LAMBERT-BAIRD 2ND ADDITION

RE: S/D 99-28 -- One-Step Final Plat of LAMBERT-BAIRD SECOND ADDITION

RE: S/D 99-28 -- One-Step Final Plat of LAMBERT-BAIRD SECOND ADDITION

CASE NUMBER: S/D 99-28 - LAMBERT - BAIRD 2ND ADDITION

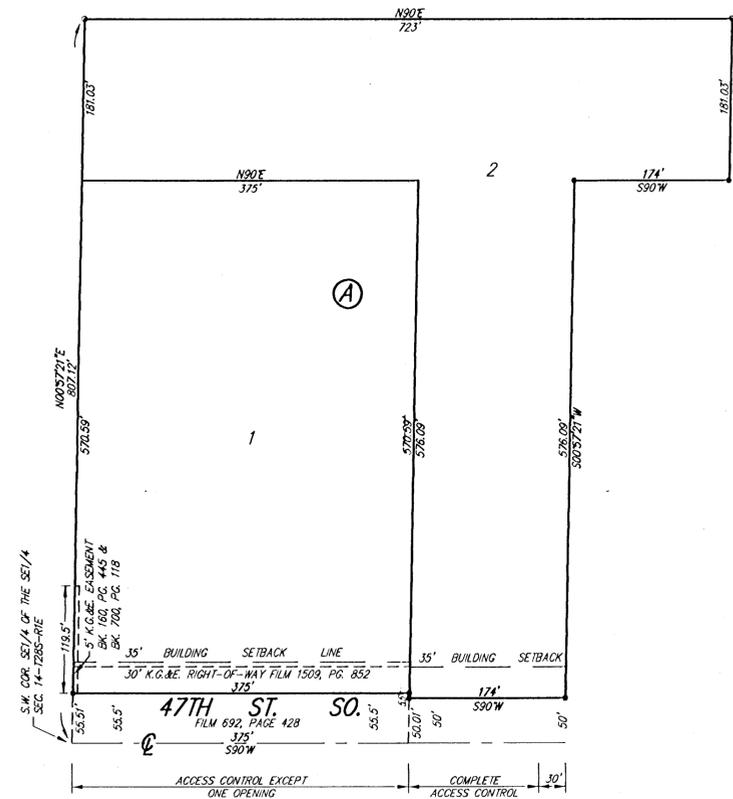
- C. County Engineering needs to comment on the status of the applicant's drainage plan. *A drainage plan needs to be submitted. A cross-lot drainage agreement may be required.*

- D. County Engineering needs to comment on the access controls and the need for joint access. The plat has denoted two openings along 47th St. South for the western lot and one opening for the eastern lot. *County Engineering has limited the site to one access opening along each lot.*

- F. The legal description in the plat's text needs to be revised to accurately portray the land being platted. It appears that the dimension of "365 feet" should be revised to "375 feet".
